APPLICATION NO.	FILING DATE	FIRST NAMED INVENTOR	ATTORNEY DOCKET NO.	CONFIRMATION NO.
09/581,602	08/18/2000	Manabu Oumi	S004-4005(PC)	9810
40627	7590	04/19/2007	EXAMINER	
ADAMS & WILKS 17 BATTERY PLACE SUITE 1231 NEW YORK, NY 10004			PSITOS, ARISTOTELIS M	
			ART UNIT	PAPER NUMBER
			2627	
SHORTENED STATUTORY PERIOD OF RESPONSE		MAIL DATE	DELIVERY MODE	
3 MONTHS		04/19/2007	PAPER

Office Action Summary	Application No. 09/581,602	Applicant(s) OUMI ET AL.	
	Examiner Aristotelis M. Psitos	Art Unit 2627

DETAILED ACTION

FIG. 26

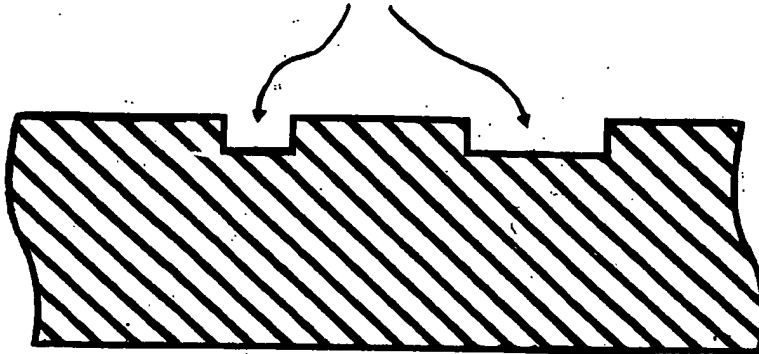
The newly submitted figures 26 and 27 have been received; however, the drawings are objected to under 37 CFR 1.83(a) because they fail to show either the groove or the optical different refractive indexes as described in the specification. Although these drawings have particular indicia indicated thereon, i.e., 1500 as in fig. 26 there is no clear indication as to what this refers to. The examiner strongly recommends labeling such indicia in both figures. Any structural detail that is essential for a proper understanding of the disclosed invention should be shown in the drawing. MPEP § 608.02(d). Corrected drawing sheets in compliance with 37 CFR 1.121(d) are required in reply to the Office action to avoid abandonment of the application. Any amended replacement-drawing sheet should include all of the figures appearing on the immediate prior version of the sheet, even if only one figure is being amended. The figure or figure number of an amended drawing should not be labeled as "amended." If a drawing figure is to be canceled, the appropriate figure must be removed from the replacement sheet, and where necessary, the remaining figures must be renumbered and appropriate changes made to the brief description of the several views of the drawings for consistency. Additional replacement sheets may be necessary to show the renumbering of the remaining figures. Each drawing sheet submitted after the filing date of an application must be labeled in the top margin as either "Replacement Sheet" or "New Sheet" pursuant to 37 CFR 1.121(d). If the examiner does not accept the changes, the applicant will be notified and informed of any required corrective action in the next Office action. The objection to the drawings will not be held in abeyance.

do not enter
